Planning Commission Staff Report

Petition: **P.Z. 19-2021 2030 Clarkson Road (Srilakshmi Properties, LLC)**: A request for a zoning map amendment from the “NU” Non-Urban District to “R5” Residential District for 2.84 acres located on the north side of Old Clarkson Road and southeast side of Clarkson Road (20T640517).

March 16, 2022

Re: 2030 Clarkson Road – P.Z. 19-2021

ZONING EXHIBIT

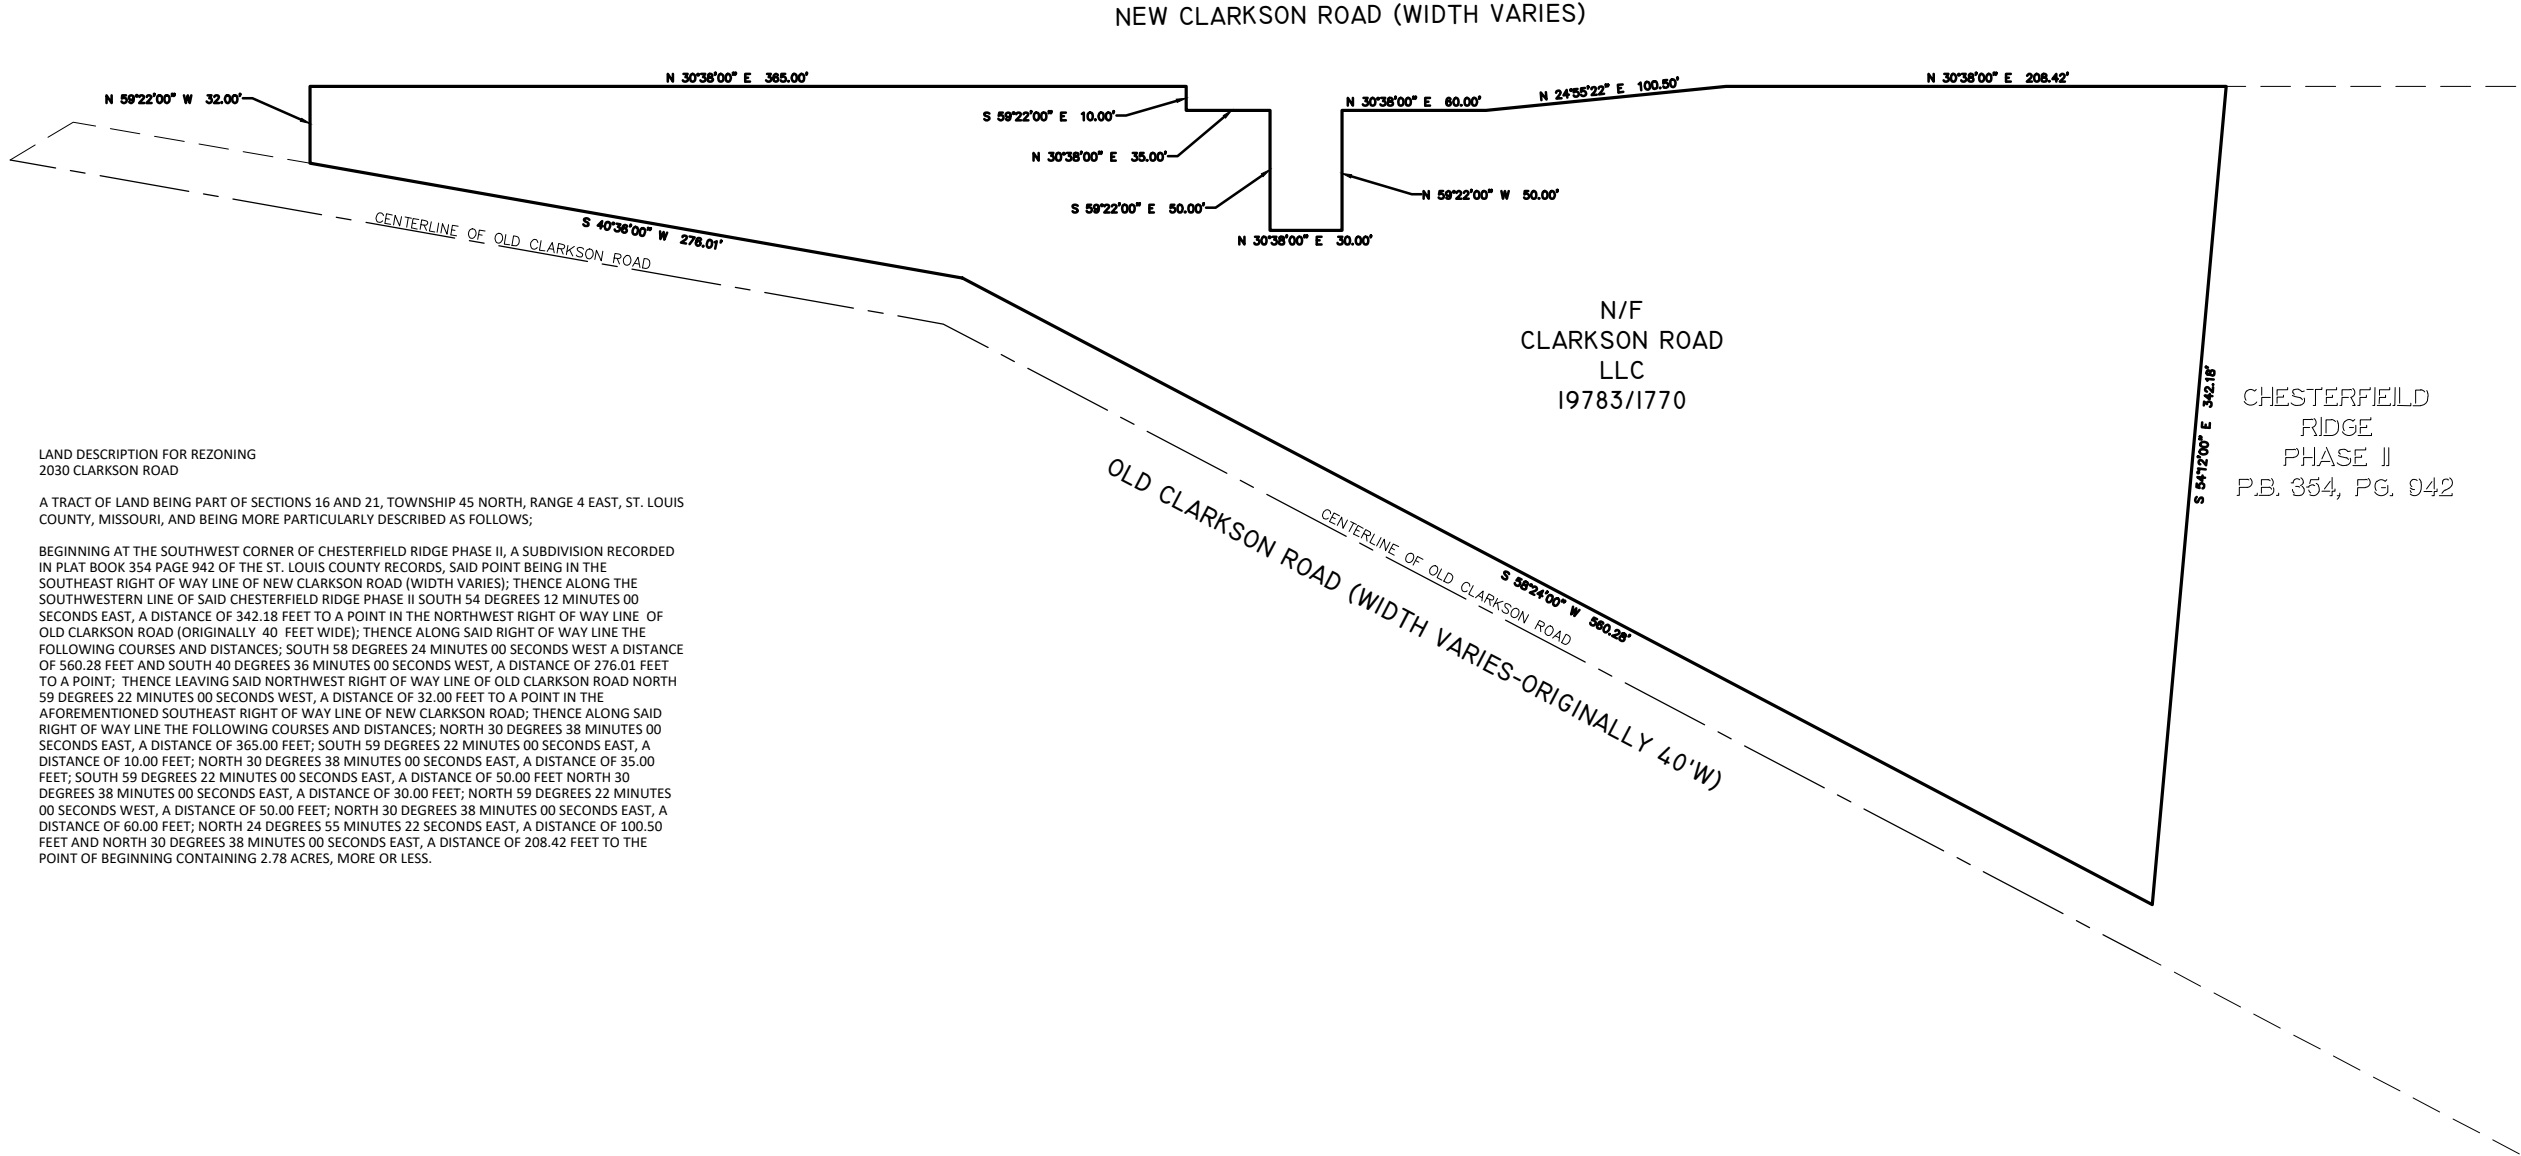
Concerns were raised regarding the legal description. The acreage of the site is depicted as 2.84 acres in accordance with St. Louis County but the acreage stated in the application is 3.44 acres. The Survey submitted is an old survey. Provide an updated survey depicting the current property boundaries.

1. Concerns were raised regarding the legal description. The acreage of the site is depicted as 2.84 acres in accordance with St. Louis County but the acreage stated in the application is 3.44 acres. The Survey submitted is an old survey. Provide an updated survey depicting the current property boundaries.

Response: An updated survey is provided.

- An updated survey will be provided.
2. Multiple concerns were raised in regards to storm water. Items include but are not limited to the current condition of the site, additional water due to impervious surface and the flow of storm water towards Old Clarkson Road and the existing neighborhoods to the east. Provide information on how the development team will be addressing the above concerns with the present and future storm water conditions. This includes documentation on the current watershed information that exist for the site.

3/18/2022	REVISED PER ACTUAL BOUNDARY
3/28/2022	REMOVED ROW FROM DESCRIPTION
	REVISED LAND DESCRIPTION

TREE STUDY

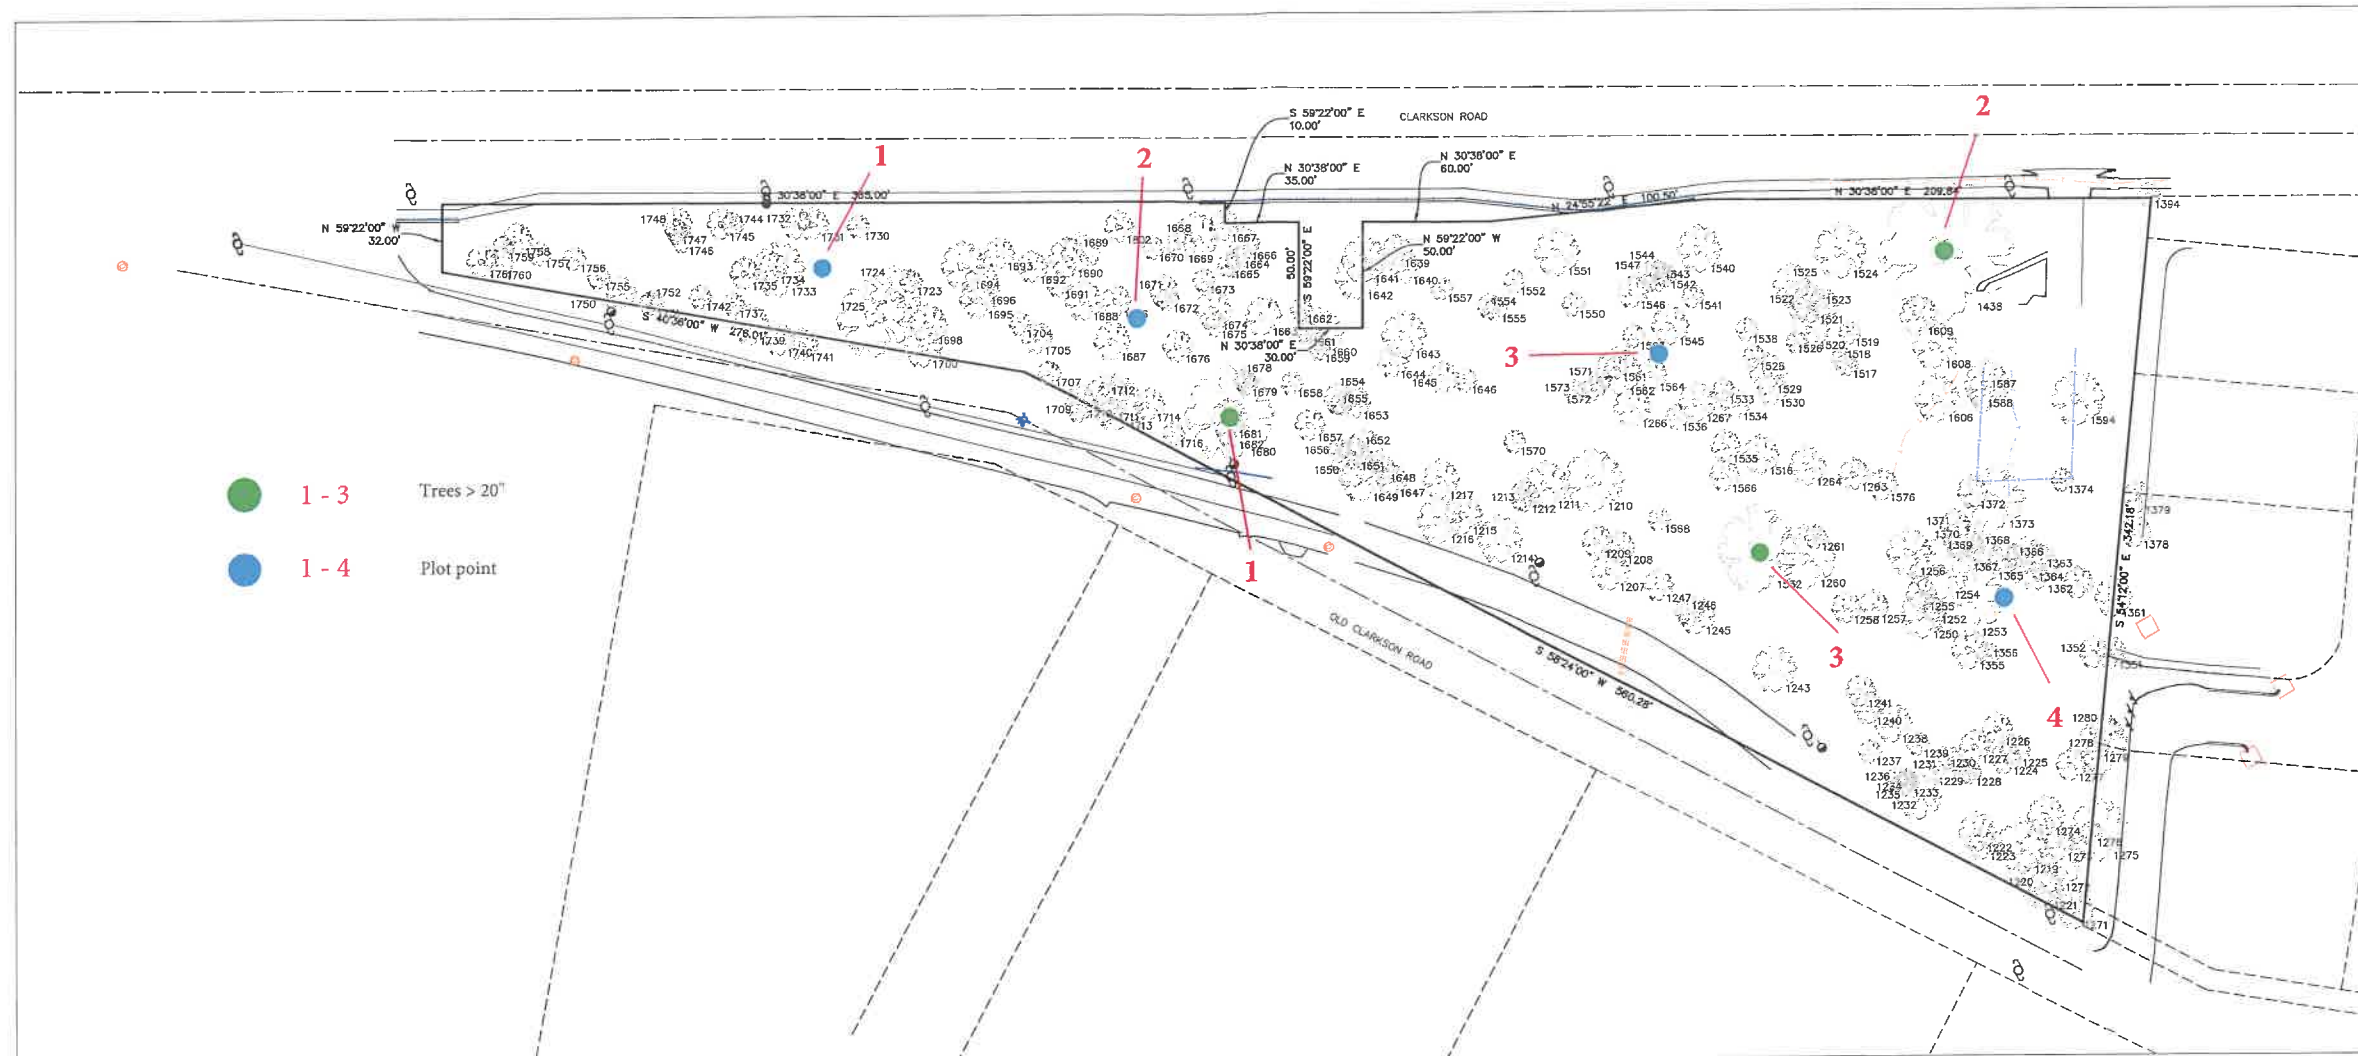
1. As per City of Chesterfield Unified Development Code Section 405.04.020 F point 4 (a) “Tree Stand Delineation shall be signed and sealed by a tree specialist.”
 - Acknowledged and addressed.
2. Provide the location, type, and size of all Monarch Trees as shown on the TSD and the critical root zone for those Monarch Trees within fifty (50) feet of the limit of disturbance. A Monarch Tree is defined in the City’s Unified Development Code and detailed below.
 - Acknowledged and addressed.

3. The total acreage of trees shall be provided on the TSD as this is the quantity utilized to capture the 30% tree preservation requirement in the City's Unified Development Code. Amend accordingly.
 - Acknowledged and addressed.
